10.4 Other Features of Steam and Power Conversion

The information in this section of the reference ABWR DCD, including all subsections, tables, and figures is incorporated by reference with the following departures and supplements.

Figure 10.4-1 Main Condenser Evacuation System

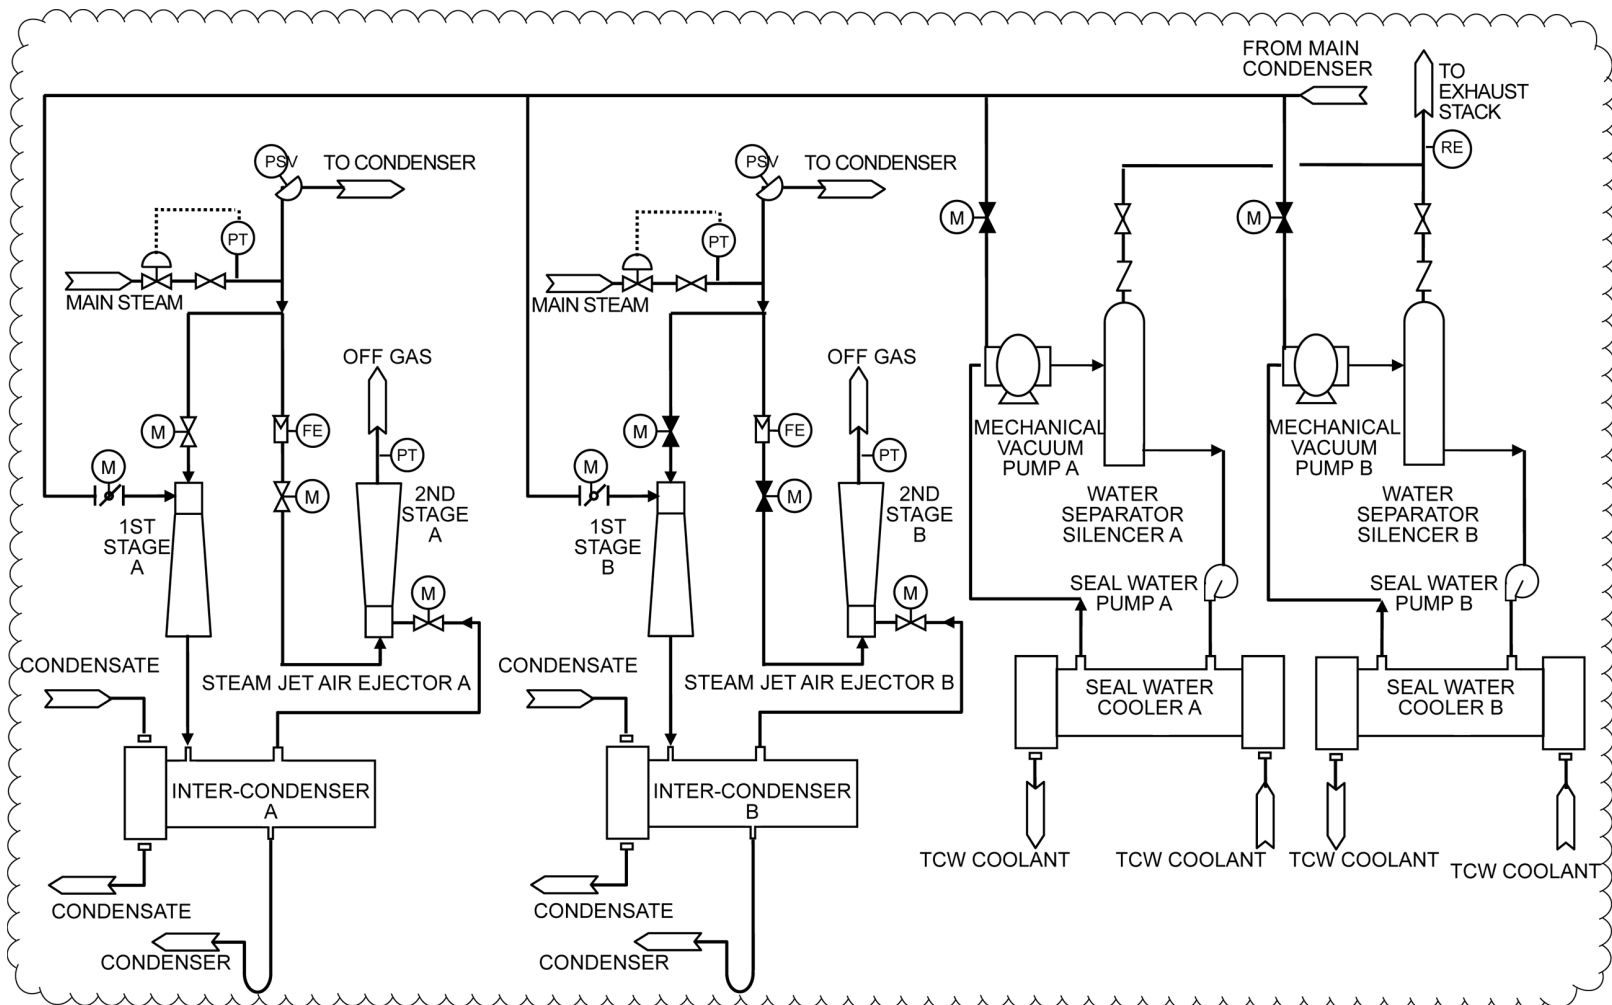
STP DEP 10.4-3 (Table 10.4-2, Figure 10.4-1)

The MCES (figure 10.4-1) consists of two 100%-capacity, double stage, steam jet air ejector (SJAE) units (complete with ~~intercondenser~~ intercondensers) for power plant operation, and ~~a two, 100% mechanical vacuum pump pumps~~ for use during startup. The last stage of the SJAE is a noncondensing stage. One SJAE unit is normally in operation and the other is on standby.

During the initial phase of startup, when the desired rate of air and gas removal exceeds the capacity of the steam jet air ejectors, and nuclear steam pressure is not adequate to operate the SJAE units, the mechanical vacuum ~~pump pumps~~ establishes ~~establish~~ a vacuum in the main condenser and other parts of the power cycle. The discharge from the vacuum ~~pump pumps~~ is then routed to the ~~Turbine Building compartment exhaust system~~ plant vent stack, since there is then little or no effluent radioactivity present. Radiation detectors in the ~~Turbine Building compartment exhaust system~~ Offgas collecting duct and plant vent alarm in the main control room if abnormal radioactivity is detected (Section 7.6). Radiation monitors are provided on the main steamlines which trip the vacuum ~~pump pumps~~ if abnormal radioactivity is detected in the steam being supplied to the condenser.

The SJAEs are placed in service to remove the gases from the main condenser after a pressure of about ~~0.034 to 0.051 MPa~~ 7kPa absolute or less is established in the main condenser by the mechanical vacuum pumps and when sufficient nuclear steam pressure is available.

During normal power operations, the SJAEs are ~~normally~~ driven by ~~crossaround steam, with the main steam supply on automatic standby. The main steam supply, however, is normally used during startup and low load operation, and auxiliary steam is available for normal use of the SJAEs during early startup, should the mechanical vacuum pump prove to be unavailable.~~

Figure 10.4-2 Turbine Gland Seal System

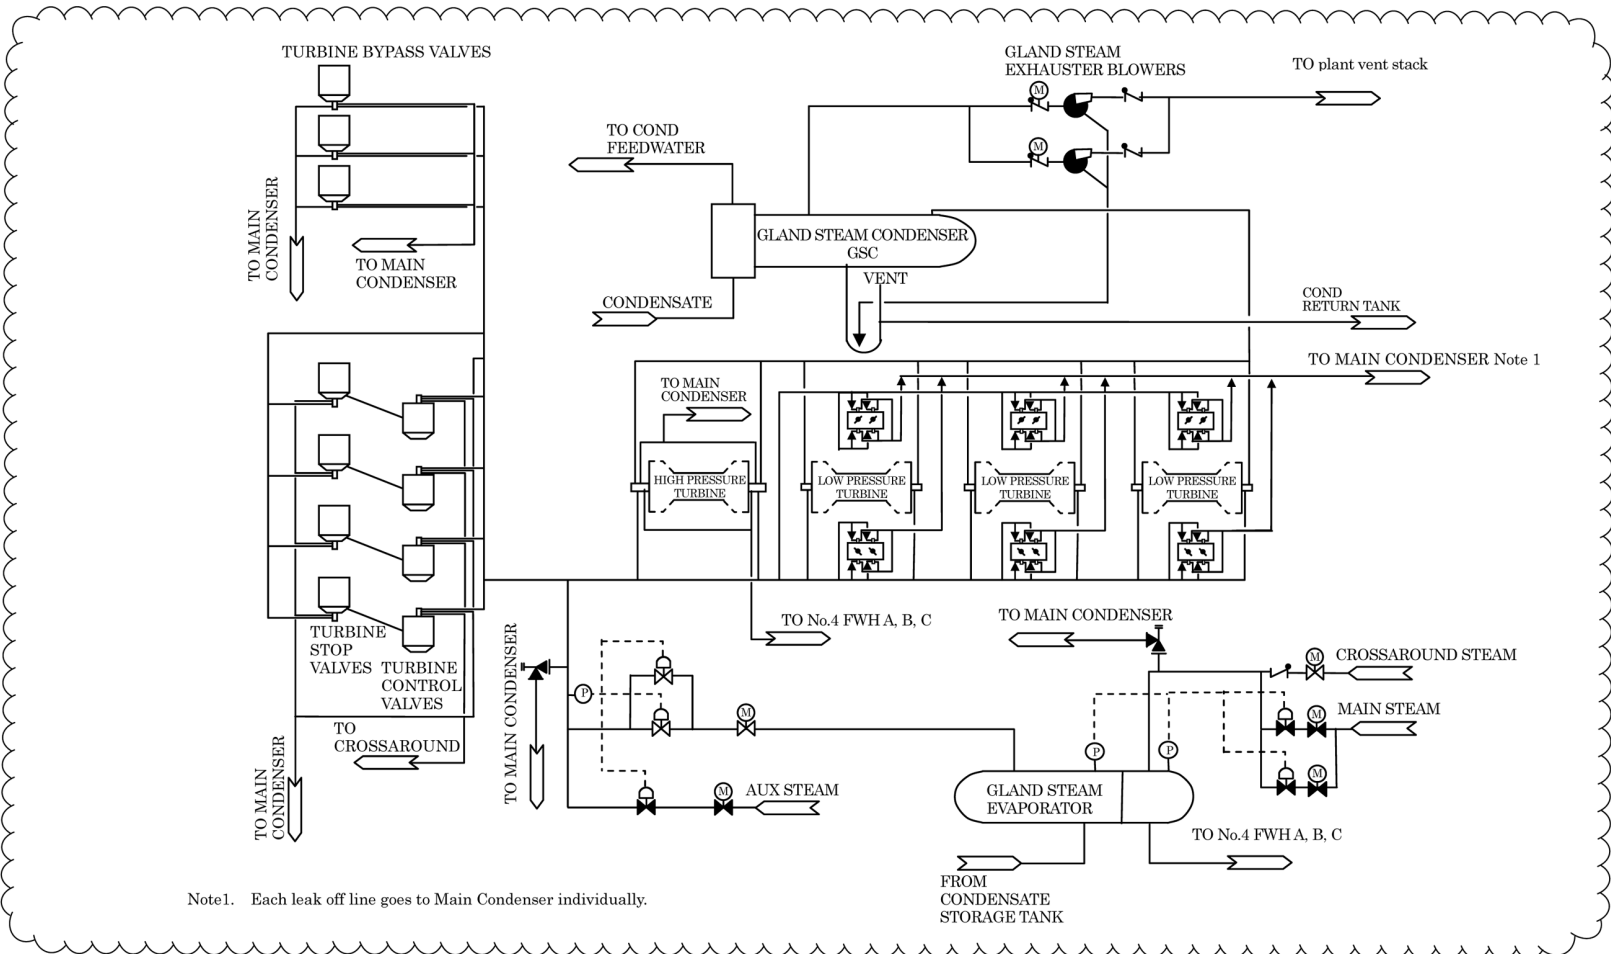
STD DEP 10.4-1 (Figure 10.4-2)

The turbine gland seal system is illustrated in Figure 10.4-2. The turbine gland seal system consists of a gland steam evaporator, sealing steam pressure regulator, sealing steam header, a gland steam condenser with two full-capacity exhausters blowers, and the associated piping, valves and instrumentation.

Figure 10.4-3 Circulating Water System

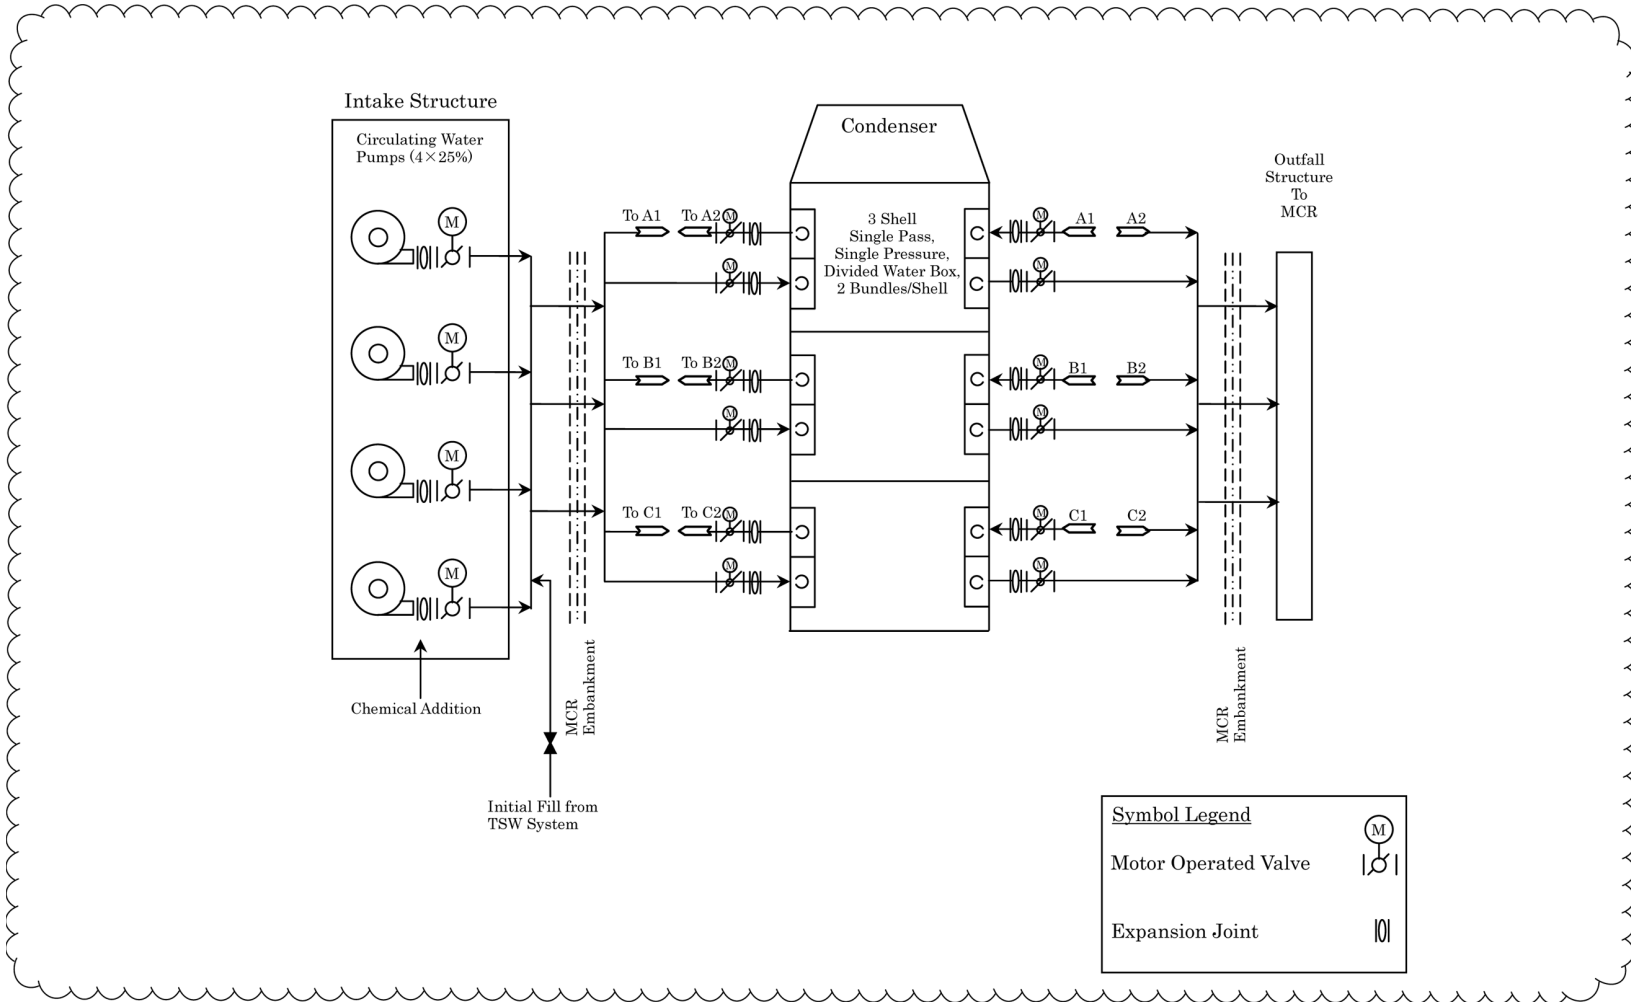
STP DEP 10.4-2 (Table 10.4-1, Table 10.4-3, Figure 10.4-3)

The main condenser is a single pass, single pressure ~~multipressure~~, three-shell, ~~reheating/~~deaerating unit. Each shell is located beneath its respective low-pressure turbine.

~~The three condenser shells are designated as the low pressure shell, the intermediate pressure shell, and the high pressure shell. The three condenser shells are cross-connected to equalize pressure. Each shell has at least two tube bundles. Circulating water flows in series~~ parallel through the three single-pass shells (Figure 10.4-3).

The Circulating Water System (Figure 10.4-3) consists of the following components: (1) ~~screen house~~ intake structure and intake screens, pumps, (2) condenser water boxes and piping and valves, (3) tube side of the main condenser, (4) water box fill and drain subsystem, and (5) related support facilities such as for system water treatment, inventory blowdown and general maintenance.

The cooling water is circulated by ~~at least three~~ four 25% capacity fixed speed motor-driven pumps per unit.

Four 25% capacity fixed speed circulating water pumps per unit discharge into a common header shown in Figure 10.4-3. The discharge of each pump is fitted with a motor operated butterfly valve. The circulating water is pumped through the main condenser and back to the MCR via a discharge outfall at a nominal rate of 272,550 m³/h per unit. To provide capability for condenser waterbox isolation, isolation valves are located on the circulating water inlet and outlet lines.

Figure 10.4-5 Condensate System

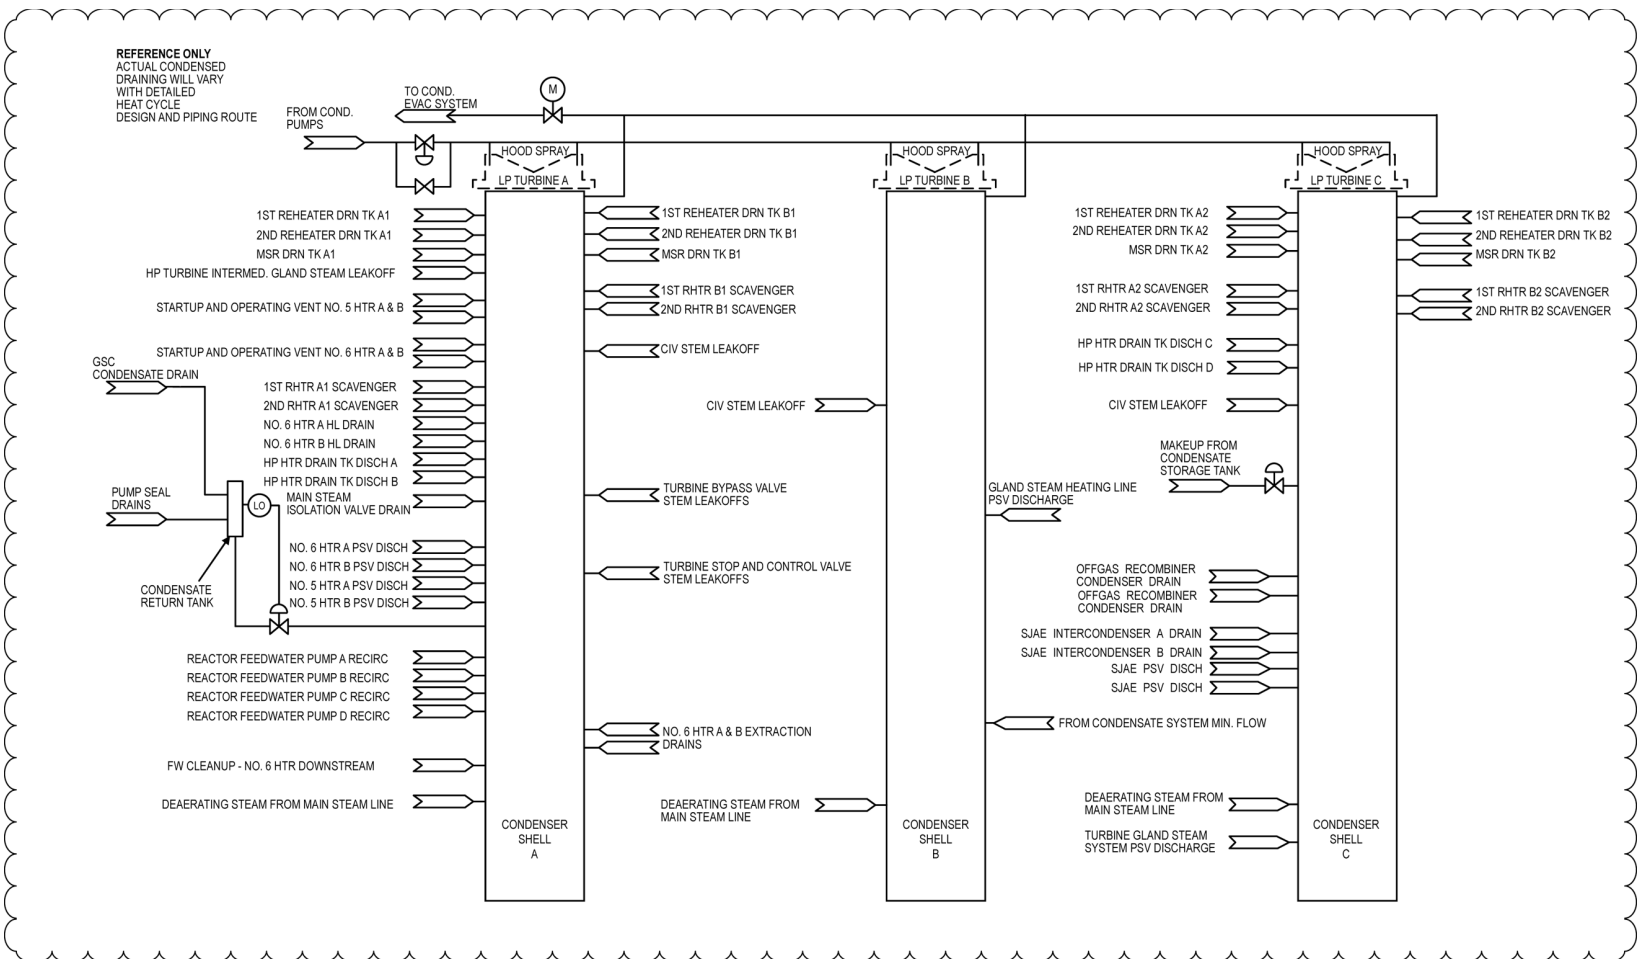
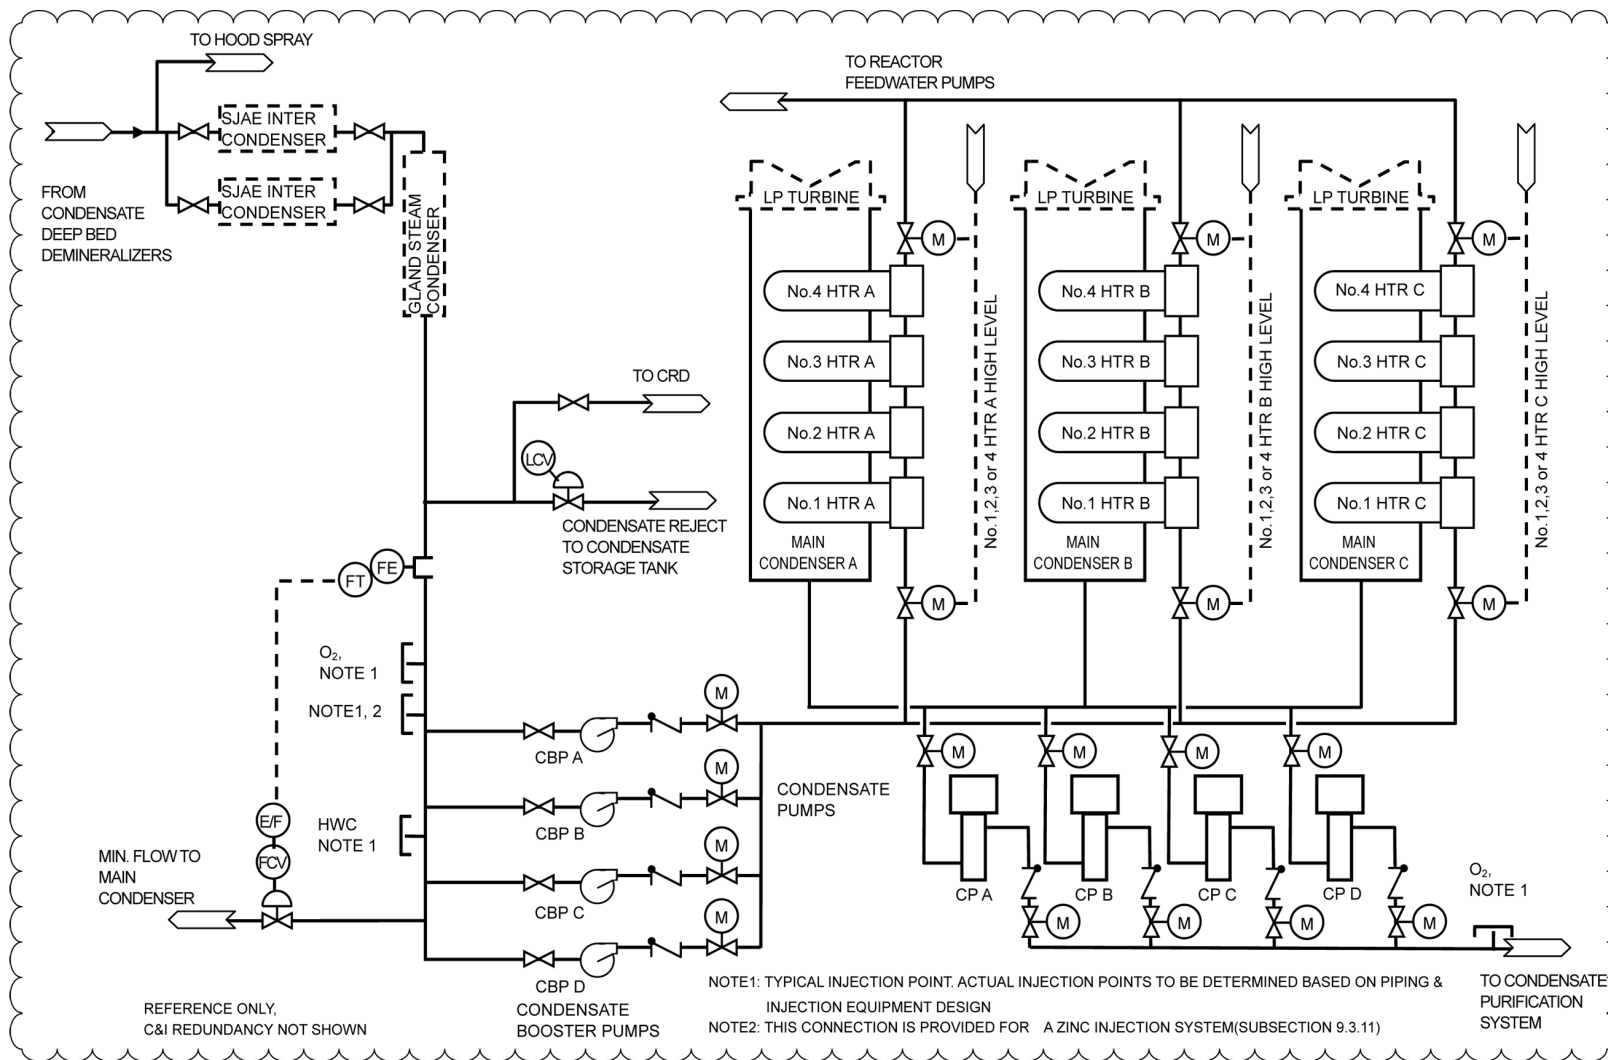
STD DEP 9.2-3 (Figure 10.4-5)

STD DEP 10.4-5 (Tables 10.4-4, 10.4-5 and 10.4-6, Figures 10.4-5, 10.4-6, 10.4-7, and 10.4-8)

The Condensate and Feedwater System (Figures 10.4-5 and 10.4-6) consists of the piping, valves, pumps, heat exchangers, controls and instrumentation, and the associated equipment and subsystems which supply the reactor with heated feedwater in a closed steam cycle utilizing regenerative feedwater heating. The system described in this subsection extends from the main condenser outlet to (but not including) the seismic interface restraint outside of containment. The remainder of the system, extending from the restraint to the reactor, is described in Chapter 5. Turbine cycle steam is utilized for a total of six stages of closed feedwater heating. The drains from each stage of the low-pressure feedwater heaters are cascaded through successively lower pressure feedwater heaters except the lowest and second lowest pressure feedwater heaters which drain to the low pressure heater drain tanks for each string. The drains from each low pressure heater drain tank flow into the external drain coolers of each lowest pressure feedwater heater and finally to the main condenser. The high pressure heater drains are pumped backward to the reactor feedwater pumps suction. The cycle extraction steam, drains and vents systems are illustrated in Figures 10.4-7 and 10.4-8.

The CFS consists of four ~~33-50%~~ 33% capacity condensate pumps (three normally operating and one on automatic standby), four 33% capacity condensate booster pumps, (three normally operating and one on automatic standby). ~~three normally operated 33-65%~~ four 33% capacity reactor feedwater pumps (three normally operating, one on automatic standby), four stages of low-pressure feedwater heaters, and two stages of high- pressure feedwater heaters, piping, valves, and instrumentation. The condensate pumps take suction from the condenser hotwell and discharge the deaerated condensate into one common header which feeds the condensate filter/demineralizers. Downstream of the condensate demineralizers, the condensate is taken by a single header and flows ~~in parallel through five~~ through the auxiliary condenser/coolers, one gland steam exhauster condenser, and two sets of SJAE condensers, ~~offgas recombiner condenser (coolers).~~ The condensate then branches into three parallel strings of low pressure feedwater heaters. Each string
